HISTORIC AND DESIGN REVIEW COMMISSION

HDRC CASE NO: 2017-298

ADDRESS: 215 E KINGS HWY NCB **LEGAL DESCRIPTION:** 6327 BLK 2 LOT 33

TYPE OF WORK: Window opening removal, installation of new window openings

215 E Kings HWY

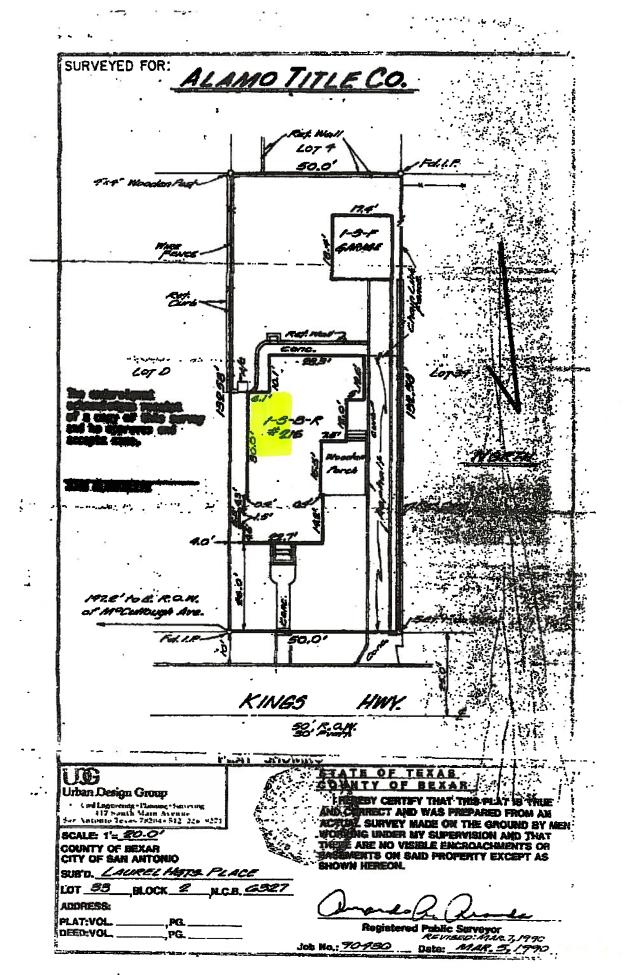
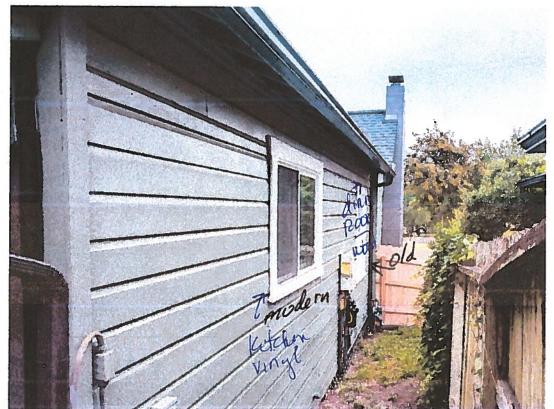
- west facing wall has one modern window + one old - faces neighbor's house - not visible from street

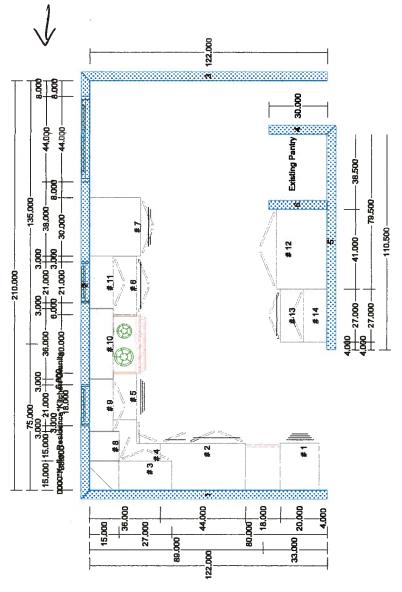
I would like the windows as large as possible, but for the boll 15"x 21". It all depends on how much space is available. Root Trim can be 3" or 4" 60 24.5" Shaded wea 60' 30 30 30 2 of which ever final size is chosen vinyl window Inside - 26" from ceiling to top of entoinets Outside - 27.5" from edge of eave to where AC election tops of rabinets will be * those will be trim on top of the cabinets, not sure of dimensions

- i. That the applicant submits final measured exterior elevation drawings that show exactly where the three windows will be located on the façade.
- ii. That the applicant submits final window specifications to include material, configuration, profile, and details to staff for approval prior to receiving a Certificate of Appropriateness. The applicant should comply with the OHP Window Policy Document.
